CANNING BRIDGE

**Report on Consideration
of Submissions**

Title	Canning Bridge Activity Centre Plan -Report on Consideration of Submissions			
Client	City of Melville			
Prepared by	Hatch RobertsDay Level 2, 442 Murray Street, Perth WA 6000			
REVISION	COMMENT	AUTHOR	APPROVED BY	DATE ISSUED
A	Draft	R.Duckham, D.Cole	D.Cole	15/03/2023

14 / Figure 1

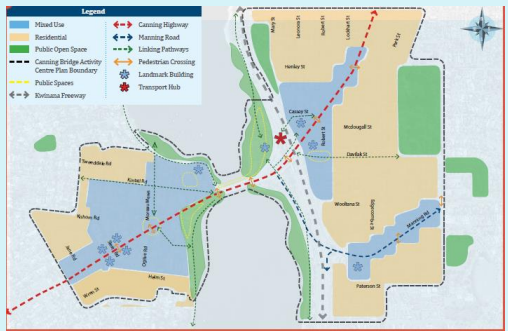
Reflects changes proposed to ACP text, heights plan, and public realm investment. The main change is the extent of Mixed Use and Residential zones in the ACP

15 / Figure 2

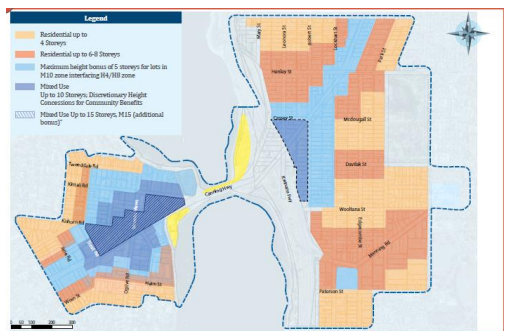
The Heights Plan changes are designed to:

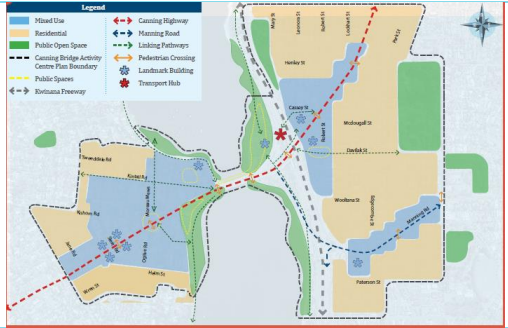
64 / Figure 1			Plan updated as per Plan 1 in Part 1 (shown on pages 5 & 14)
66 / 1.3	(Additional text)	<p>The review of the Activity Centre Plan undertaken by the City of Melville in 2020 and 2021 reviewed key elements of Quarters 1 & 2. In addition to changes to Part 1 of the ACP, relevant explanations in Part 2 of the ACP have been added to provide context for the changes made in the review.</p> <p>These additions are highlighted with light blue shading for ease of reference.</p>	<p>Introductory, descriptive text indicating the community engagement undertaken as part of the ACP review, including the reason for the review (i.e. community and Council reasons to review the ACP such as outcomes not matching expectations), a summary of the approach undertaken, and where to find further information.</p> <p>The text is included in a highlighted box, like all additional text in Part 2, to ensure material relating to the review is quickly identifiable.</p>
